Sent: 30/11/2020 9:27:52 PM
Subject: DA2020/0824 - Attention Jordan Davies
Attachments: DA letter Council - 8 Sunshine.pdf;

Attention - Jordan Davies
DA2020/0824
321-331 Condamine St, Manly Vale

We are writing to confirm our **objections** to the amended plans for DA2020/0824.

Figure 1: Extract from DA-14 Rev B Illustrating Non-Compliance

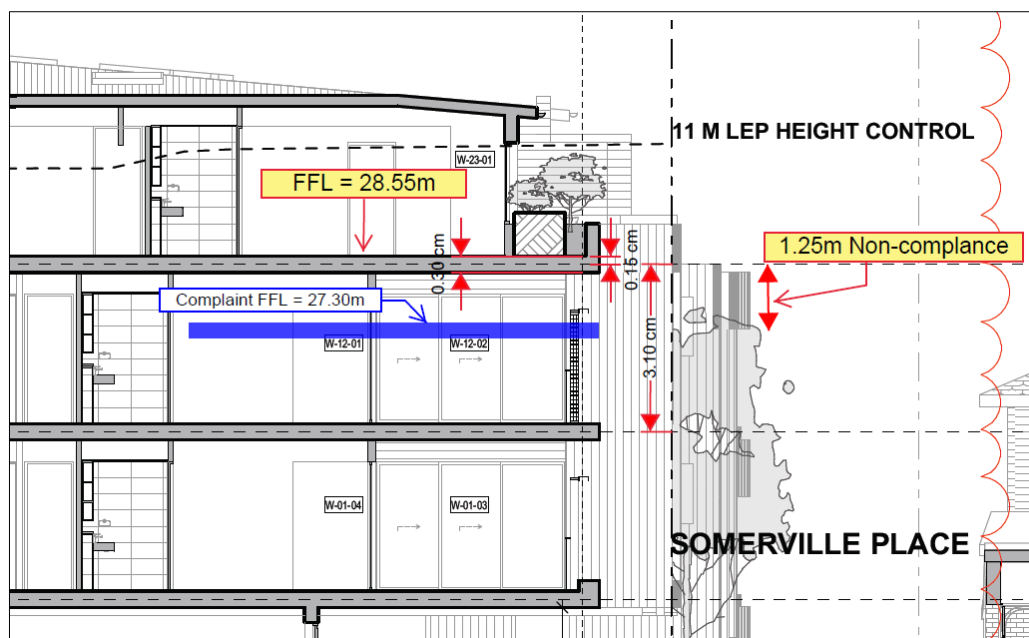
1. The Reduced Level of Somerville Place has been identified as +19.4m to +19.5m on the road to the west of the proposed development. The LEP height restrictions would therefore result in a maximum RL of +30.4m.
2. "Floor to Floor" dimensions are typically 3.1m, so the Finished Floor Level of a compliant development should be +27.3m.
3. Level 3 of drawing DA-14, Rev B, Section 3, identifies that Level 3 is +28.4m. However, the drawing is inaccurate as this level does not relate to the finished floor level which appears to be at least 150mm above at +28.55m (see Figure 1). This results in a non-compliance of 1.25m.

Figure 3: Visual Impact Expected from Compliant Development

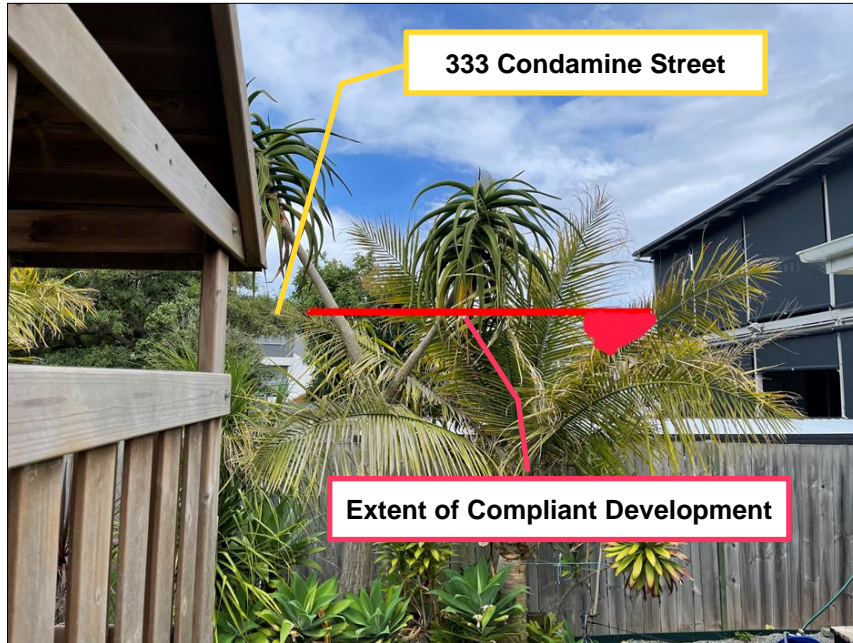
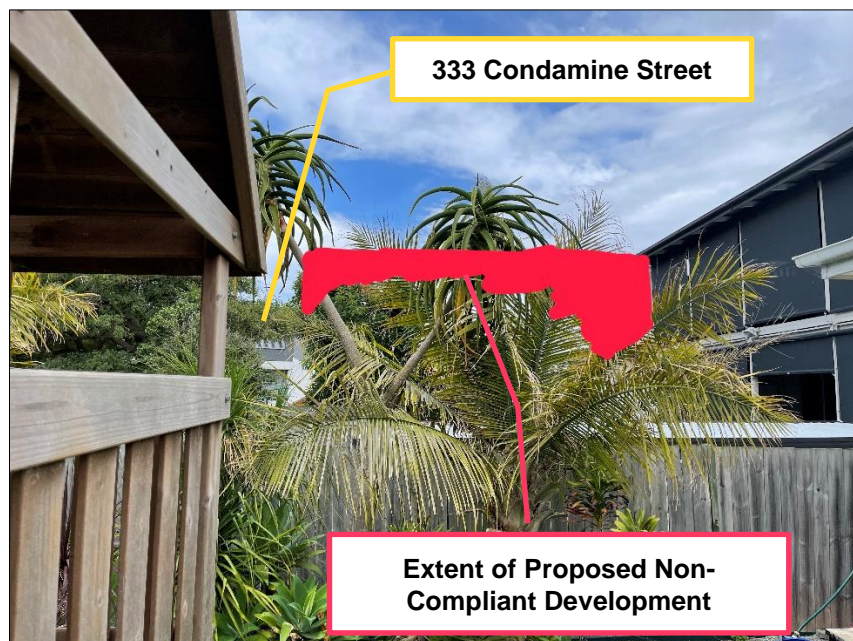
7. The proposed non-compliant building height is not sympathetic with surrounding properties and significantly increases the Visual Impact to the properties on 2, 4, 6, 8, and 10 Sunshine Street.
8. Figure 3 illustrates the extent of the impact from a single view from the rear of 8 Sunshine Street if a compliant development were to be approved. Figure 4 illustrates the extent of the impact from the same view from the proposed development. This clearly shows that there is a significant increase in visual impact due to the non-compliance.
